STAFF RECOMMENDATION
2517 Blair Boulevard
May 16, 2018

Application: New construction—addition to outbuilding
District: Hillsboro-West End Neighborhood Conservation Zoning Overlay
Council District: 18
Map and Parcel Number: 10415002700
Applicant: Blaine Bonadies
Project Lead: Melissa Baldock, melissa.baldock@nashville.gov

Recommendation Summary: Staff recommends disapproval of the addition to the outbuilding, finding that its scale, roof form, and setbacks do not meet Section II.B.h. of the Hillsboro – West End Neighborhood Conservation Zoning Overlay design guidelines

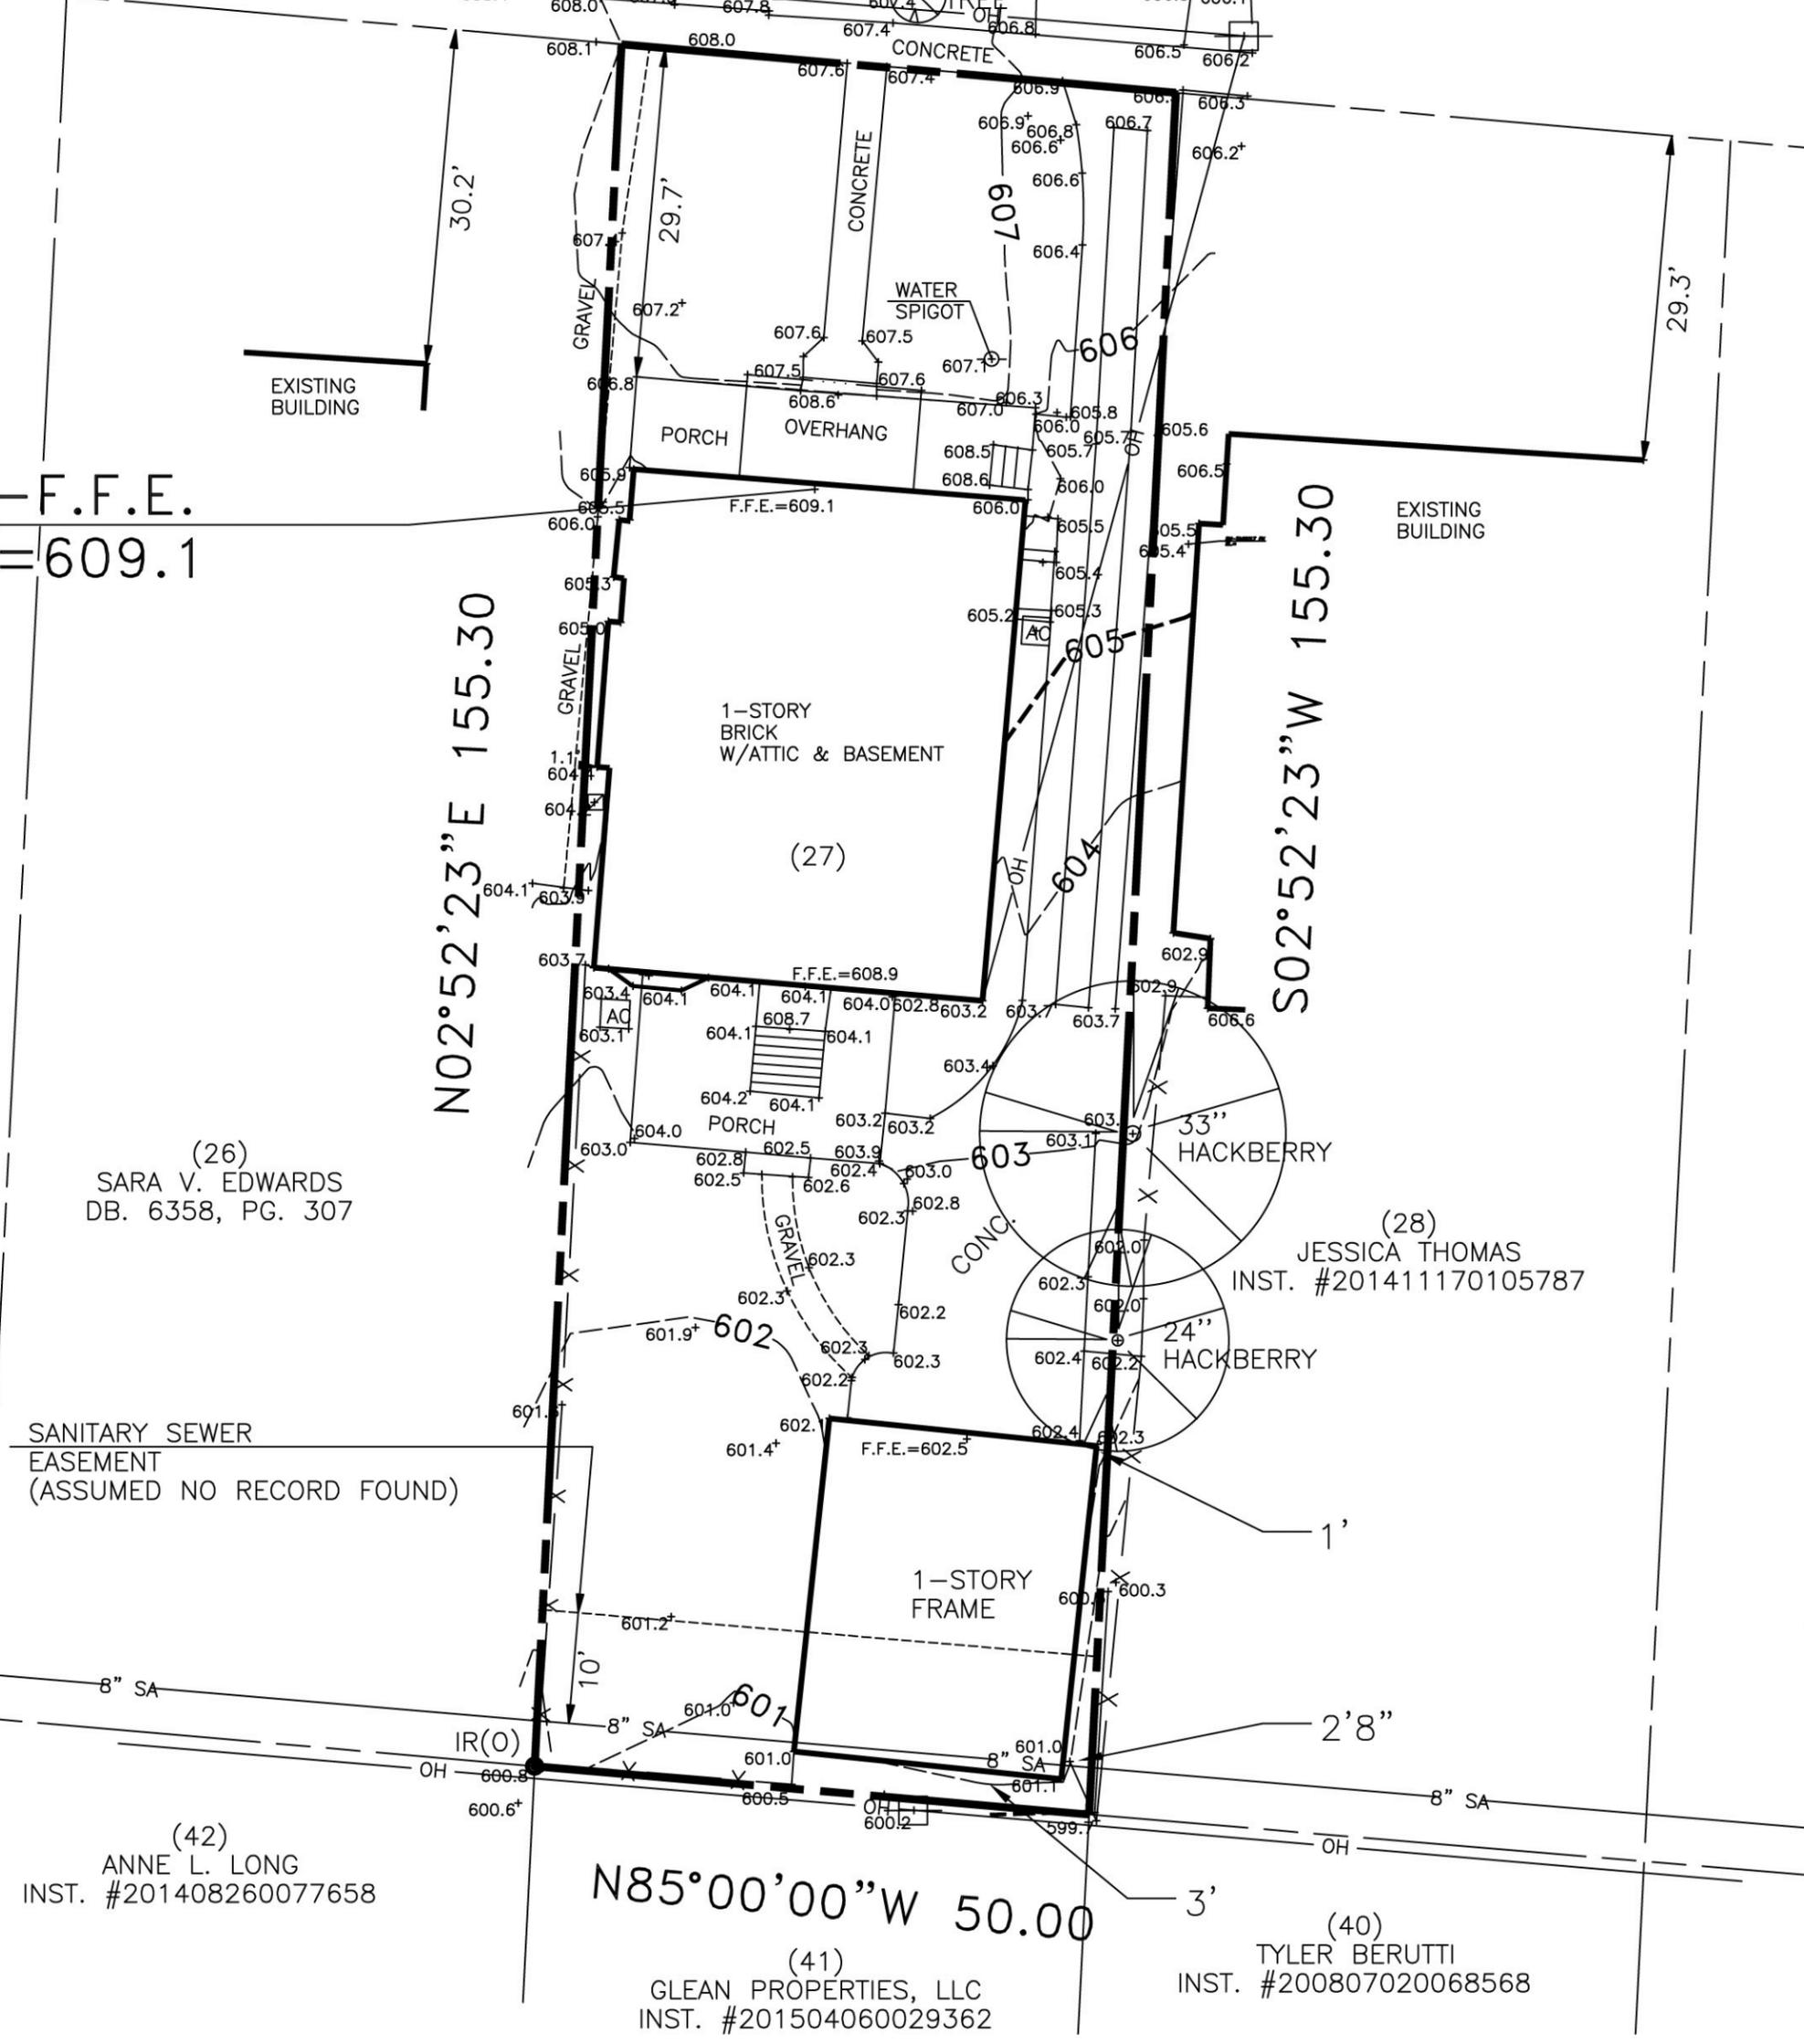
MINIMUM	PROPOSED
Building located towards rear of lot	n/a	Yes
Space between principal building and DADU/Garage	20'	35'
Rear setback	3'	3'
L side setback**	5'	1' *
R side setback**	5'	23'
How is the building accessed?	From the alley or existing curb cut	Existing curb cut

* Base zoning requires a five foot (5') side setback when the outbuilding's footprint is larger than seven hundred and square feet (700 sq. ft.) like this one. The existing outbuilding is seven hundred and eighteen square feet (718 sq. ft.). It does not meet base zoning setback on the left side. The existing structure is just one foot (1') from the left side property line towards the front and is approximately two feet, eight inches (2'8") from the side property line at its rear. Staff finds that increasing the height of the outbuilding from one-story to one-and-a-half-stories and from approximately sixteen feet (16') tall to twenty-two feet (22') tall increases the non-conformity of the setbacks and is not appropriate. Staff therefore finds that the project does not meet Section II.B.h.2 of the design guidelines.

right elevation

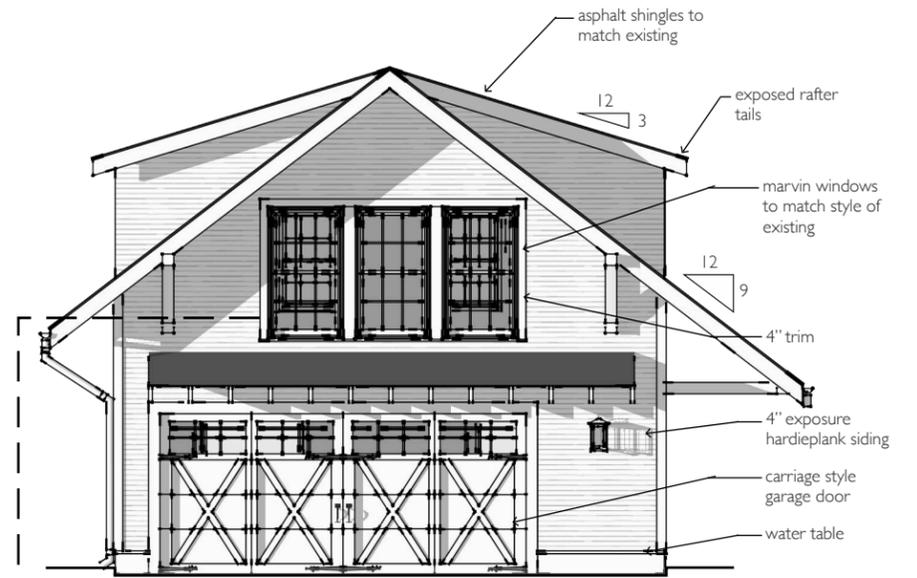
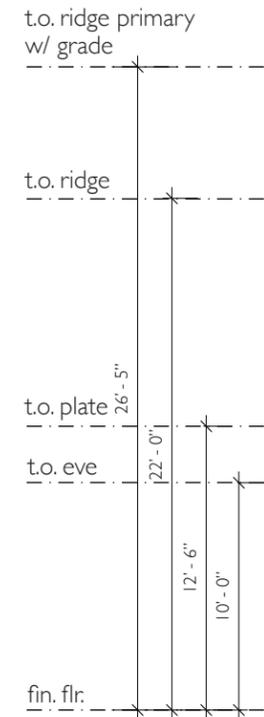
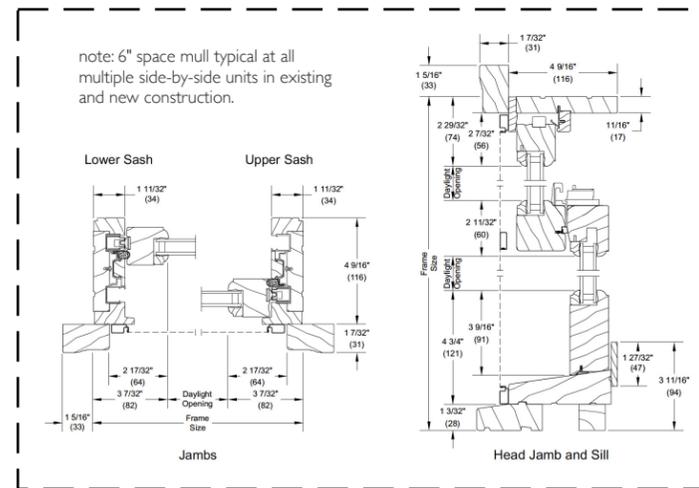
The italicized portion of the design guidelines states, “*The DADU or outbuilding may have dormers that relate to the style and proportion of windows on the DADU and shall be subordinate to the roof slope by covering no more than fifty percent of the roof plane and should sit back from the exterior wall by 2’.*” The proposed shed dormers are not set back from the exterior walls; they stack on top of the exterior walls. In addition, they cover more than fifty percent (50%) of the roof slope. The width of the roof is thirty-five feet (35’) and the width of the dormer is twenty-six feet (26’). The dormers cover seventy-four percent (74%) of the roof slope. Staff finds that the dormers’ width and lack of an inset do not meet Section II.B.h.1. of the design guidelines.

As mentioned in the previous section, the proposed dormers are not properly inset from the exterior wall and are wider than what the design guidelines allow. Because of the out-of-scale dormers, staff finds that the proposed roof form does not meet Section II.B.h.1. of the design guidelines.

Design Standards: The addition to the outbuilding creates a one-and-a-half story outbuilding behind a one-and-a-half story house. This could be appropriate, except that the size and scale of the dormers do not meet the design guidelines, and the outbuilding does not meet the base zoning setbacks. Staff finds that the design of the addition to the outbuilding does not meet Section II.B.h.1 of the Hillsboro-West End Neighborhood Conservation Zoning Overlay design guidelines.
